Ground Floor Flat
5 Hillfield Road
London NW6 1QD

Re: Planning Reference 2021/2596/P

**Description: Site R/0 1 Hillfield Road NW6 – OBJECTION TO APP 2021/2596/P
OBJECTION BY 5 HILLFIELD ROAD – OVERSHADOWING ADDENDUM**

**Site Address: Land between Gondar House and South Mansions, Gondar
Gardens and to the rear of Hillfield Road, West Hampstead, London NW6 1QD.**

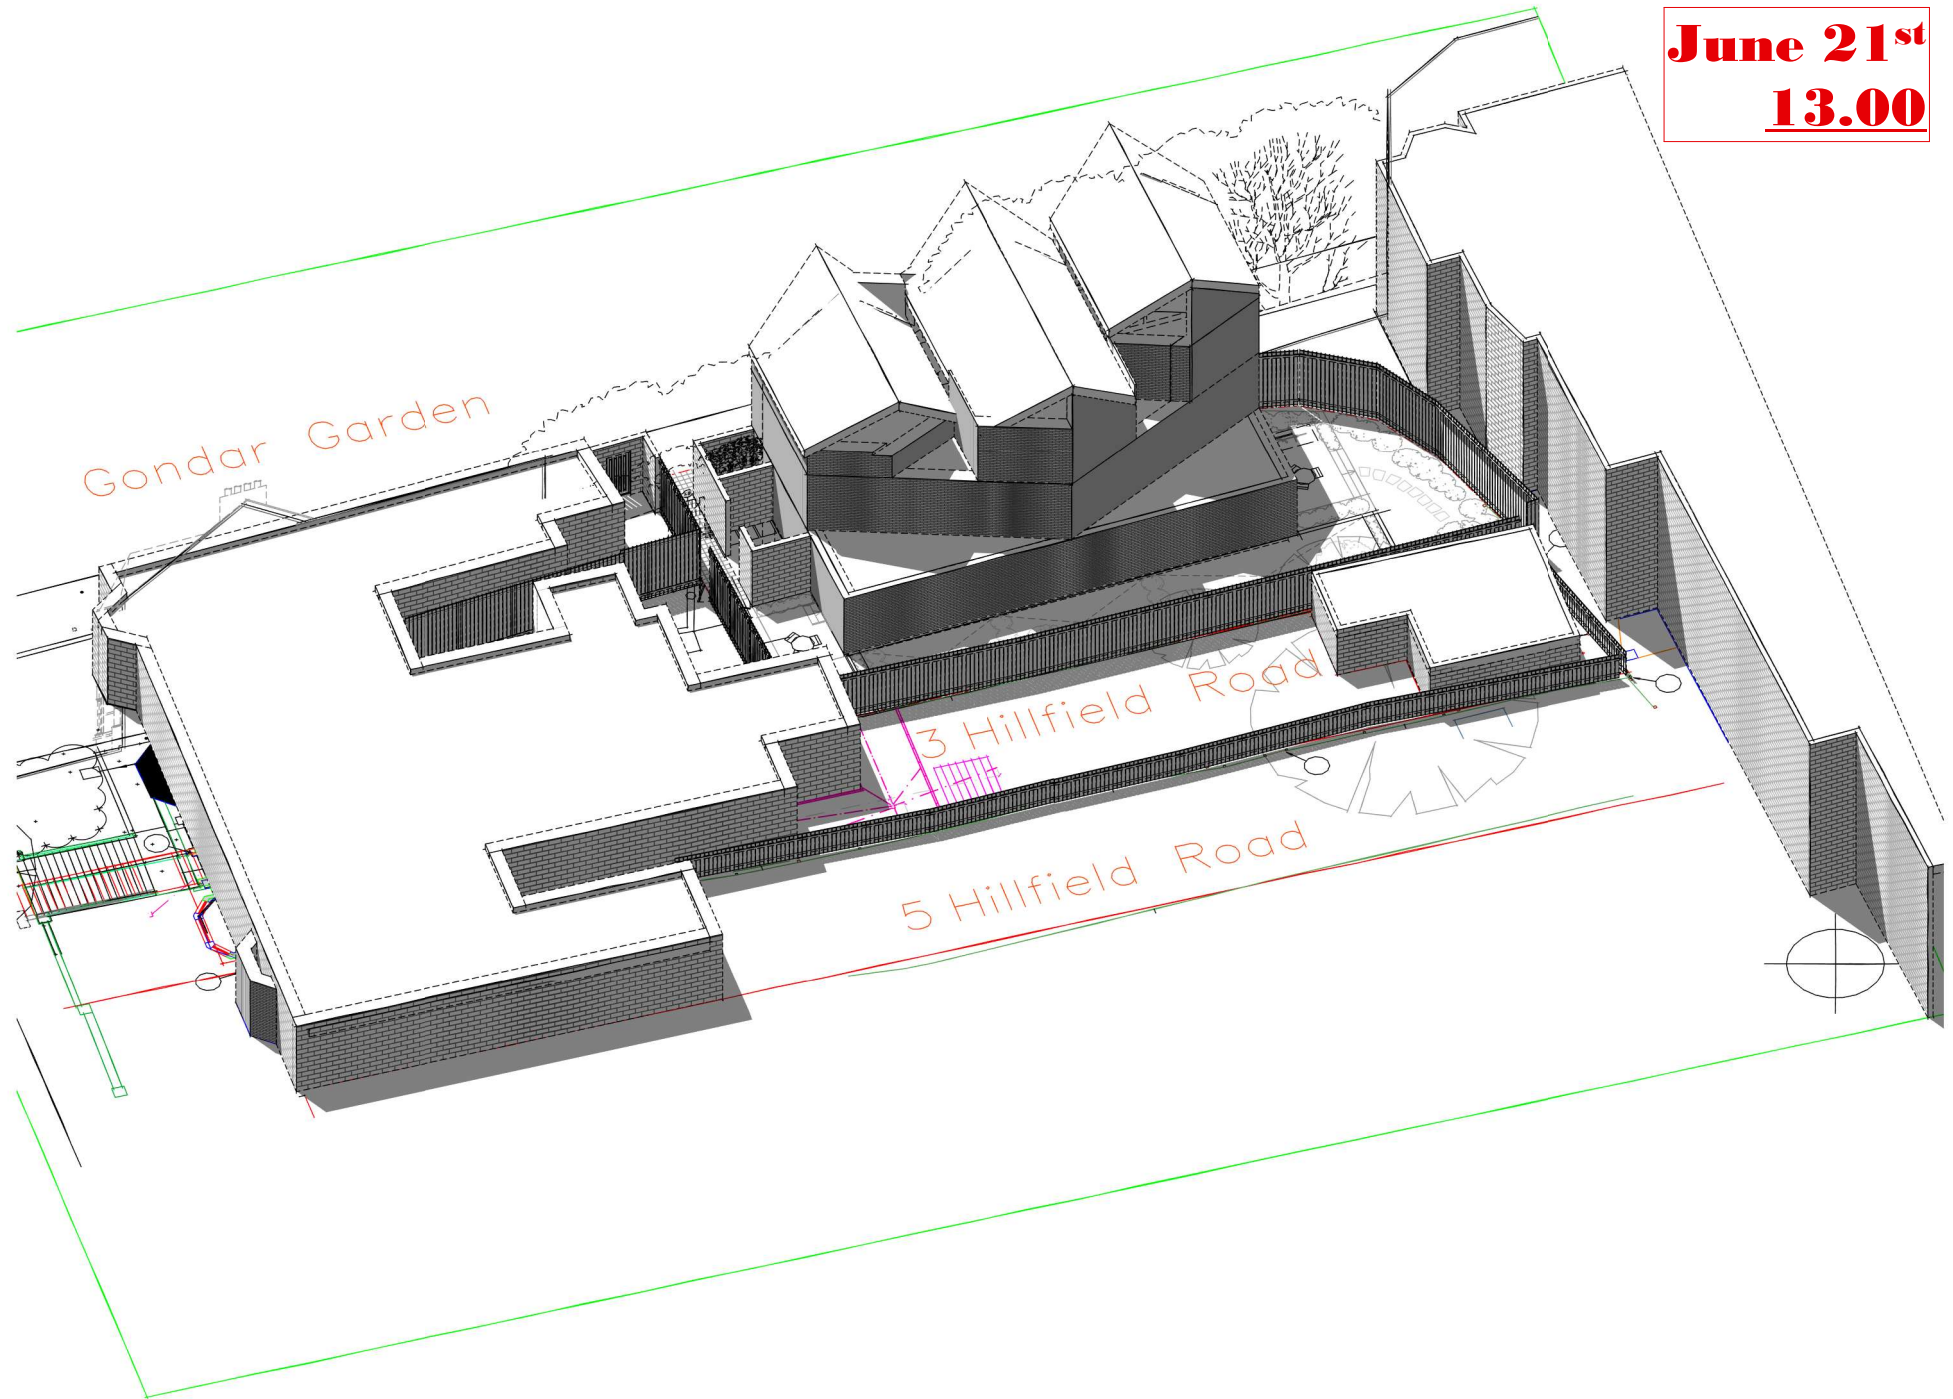
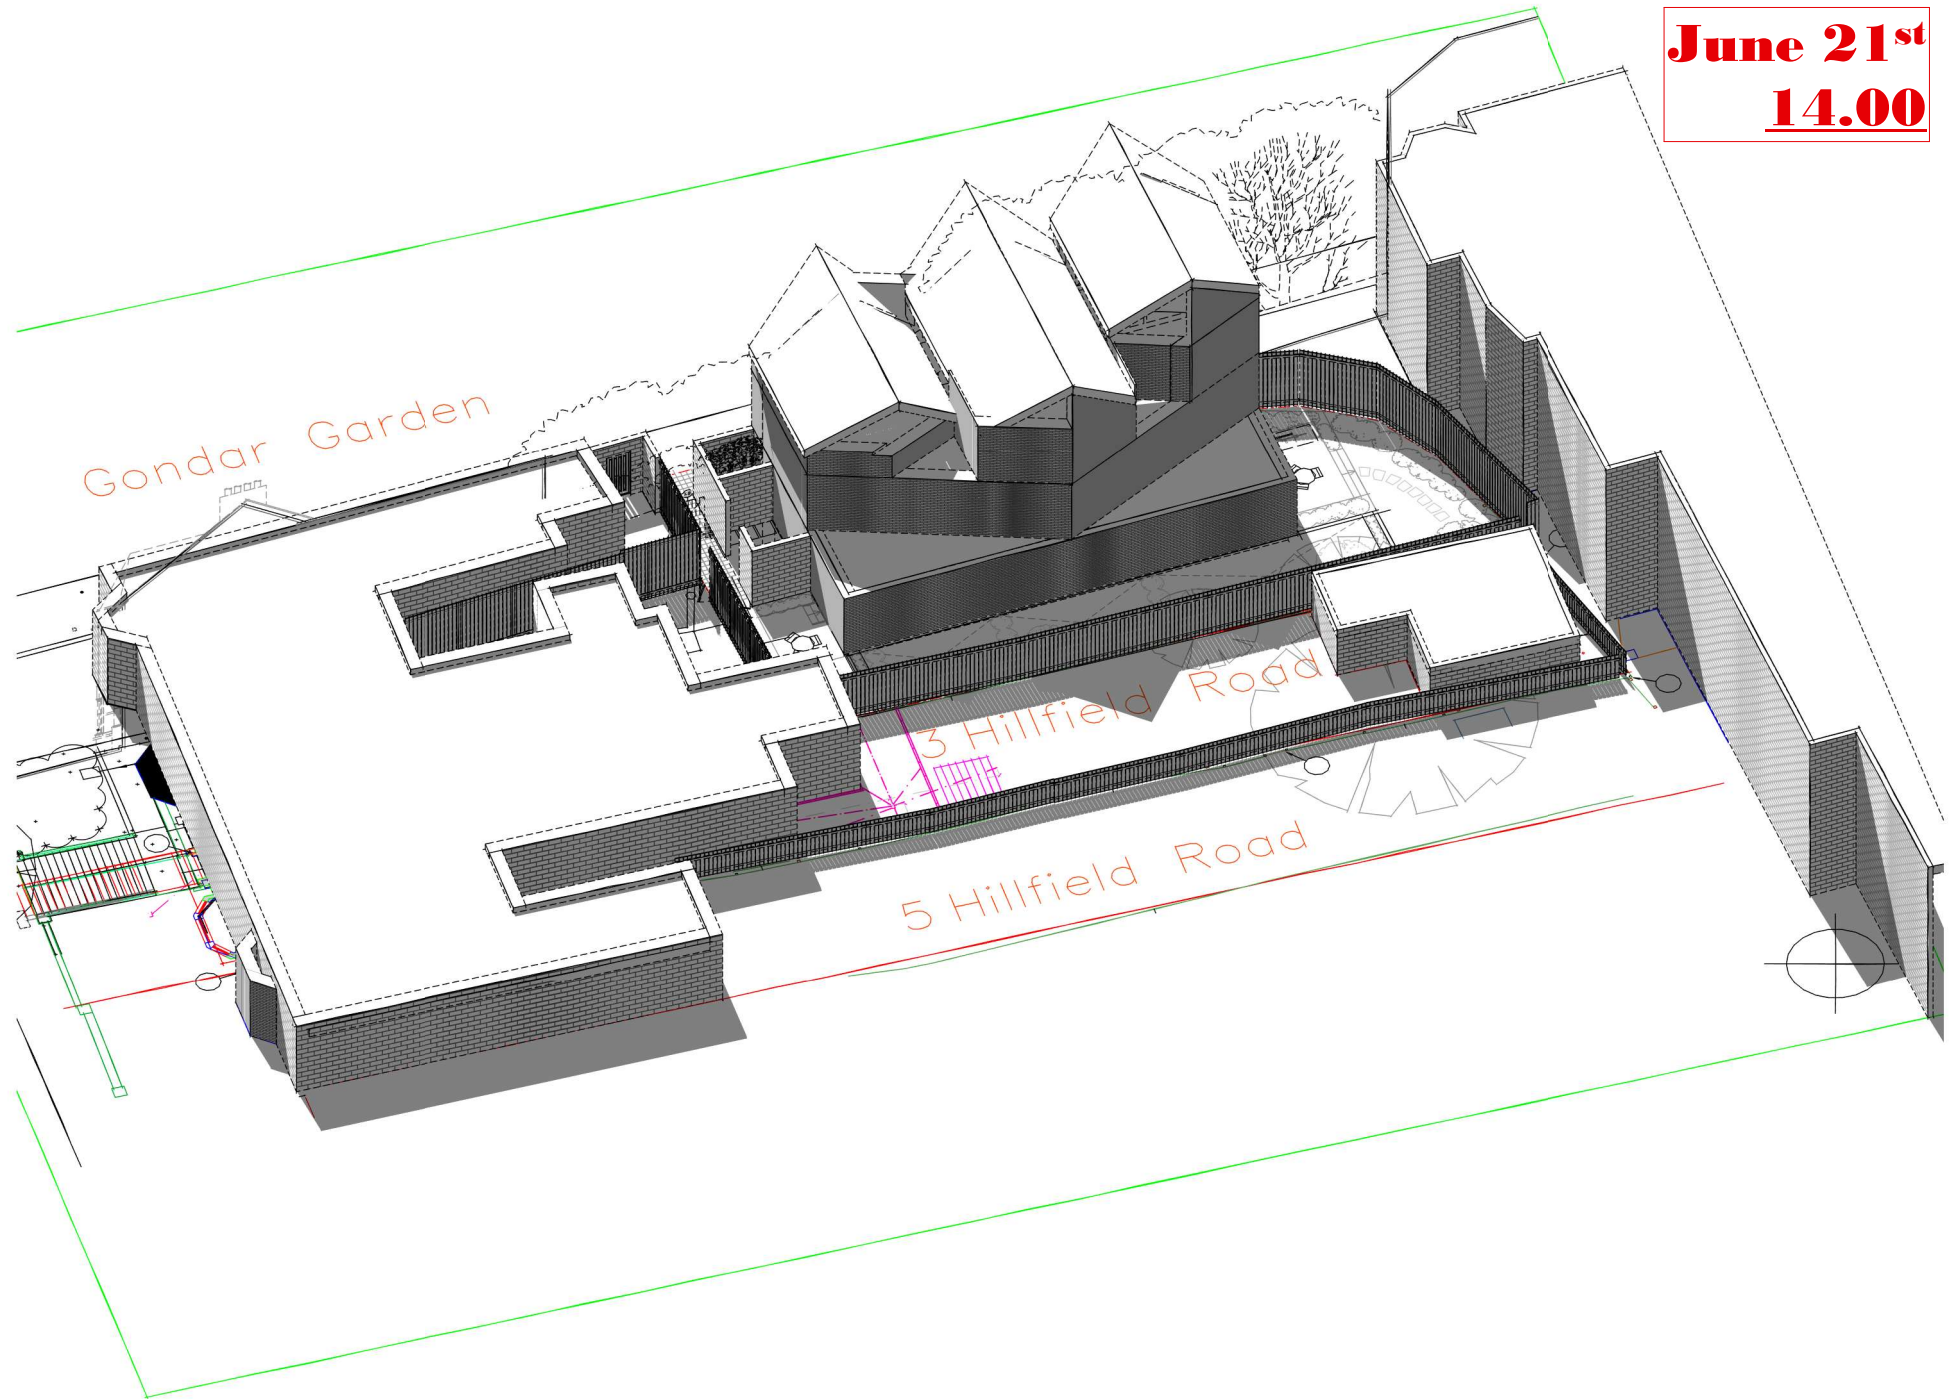
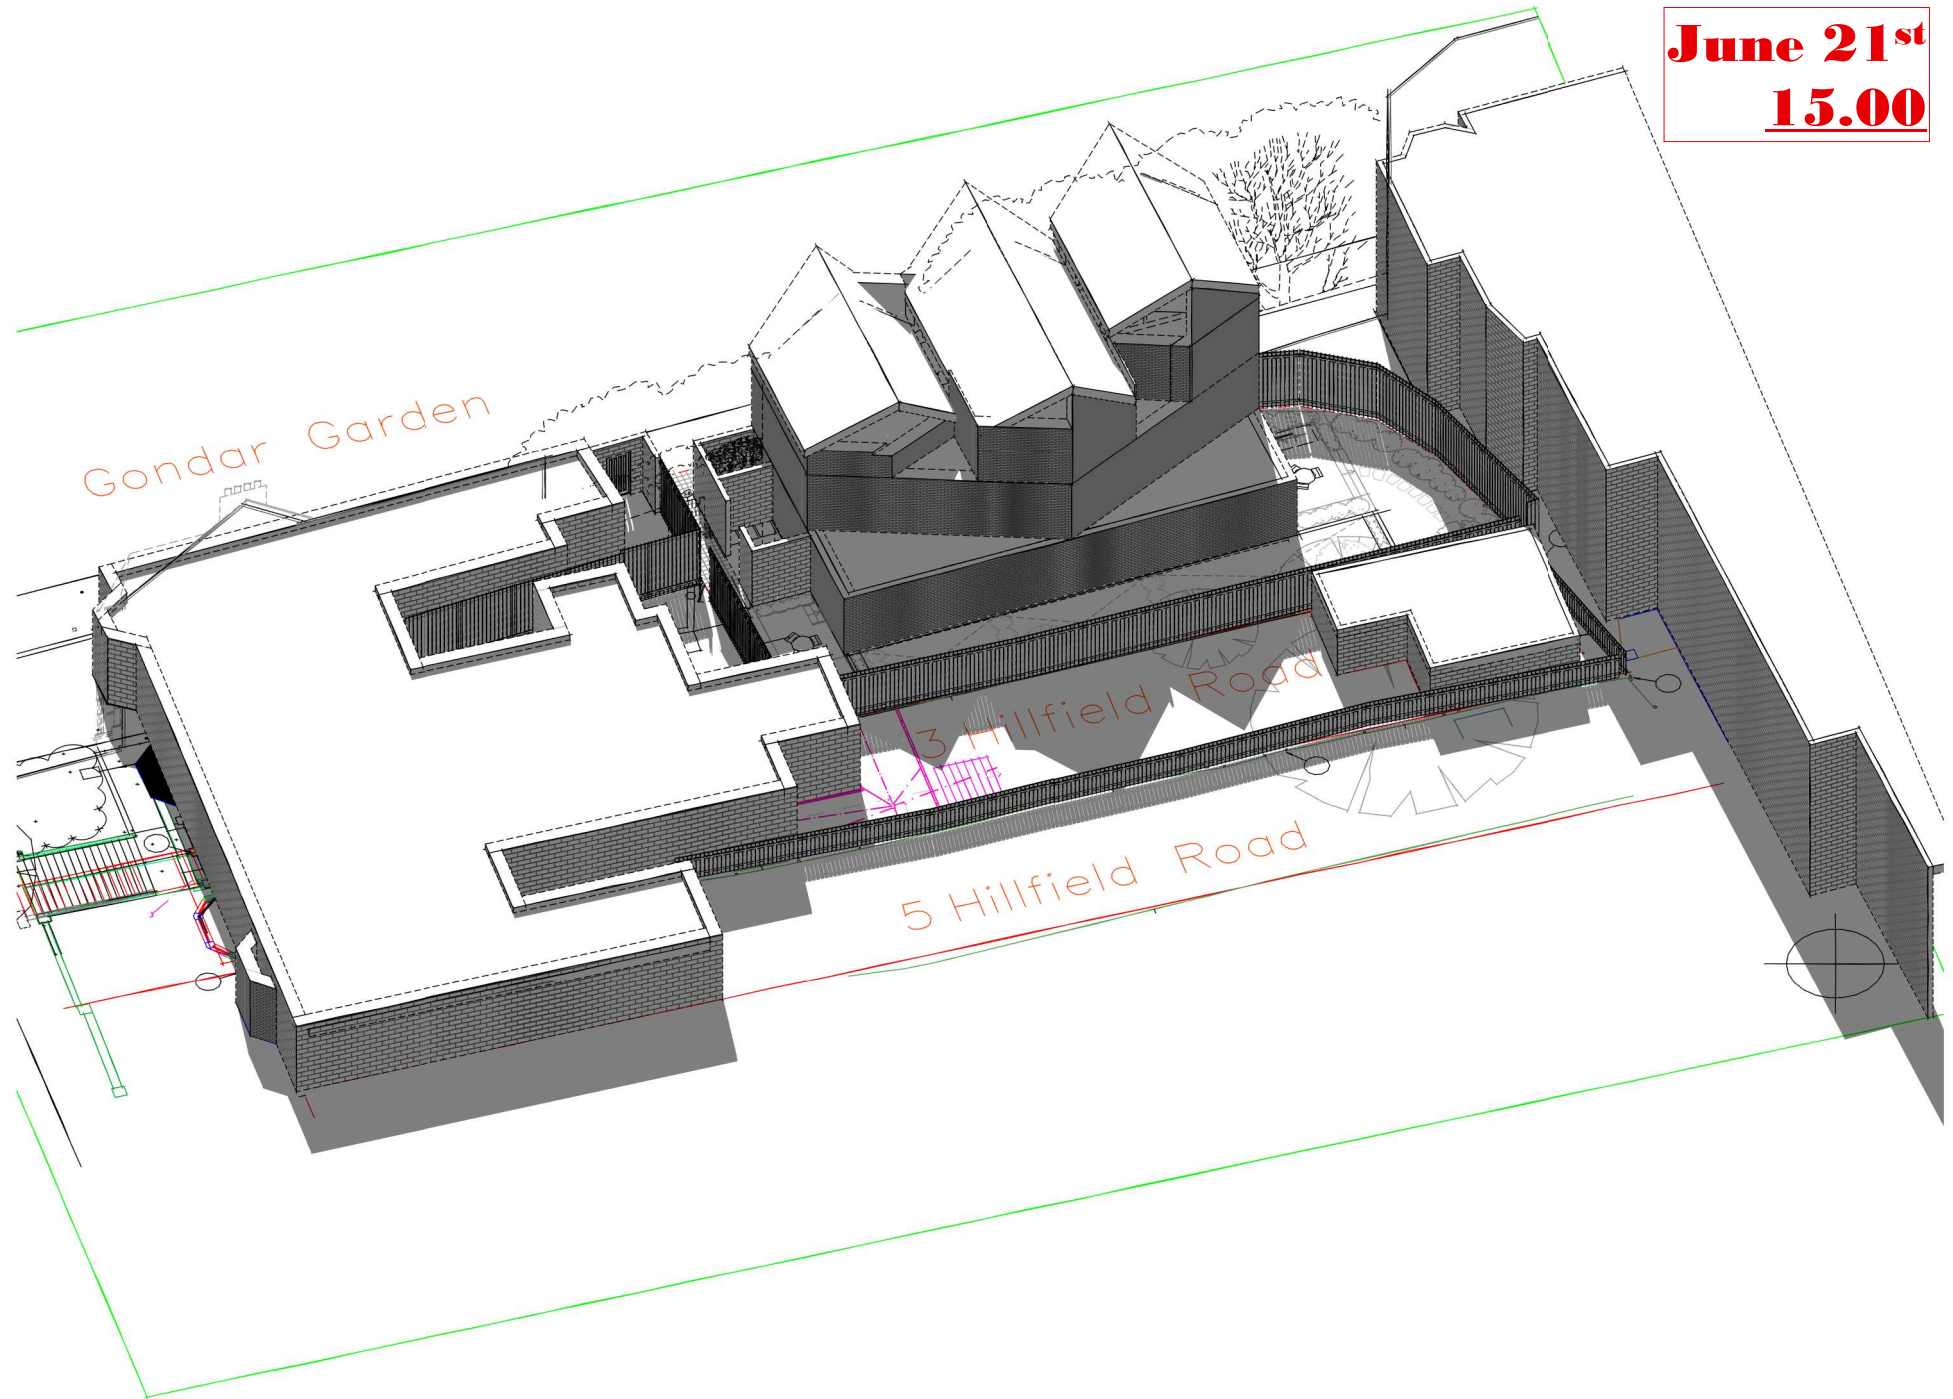
Our own modelling has Gondar House only as ground floor as such the modelling does not show full height of the building and hence not the correct overshadowing on 1 Hillfield Road patio area which will be much worse than the current modelling. The modelling was done to show the extent of overshadowing on 3,5 & 7 Hillfield Road gardens. Also, our model below shows the overshadowing at 21 March. The model shows that the sun is blocked from 14:00 o'clock on 3 Hillfield Road and from 15:00 it is blocking 5 Hillfield Road, the overshadowing continues till sunset at 18:15. We went further to do analysis in June and the overshadowing continues till sunset at 21:00.
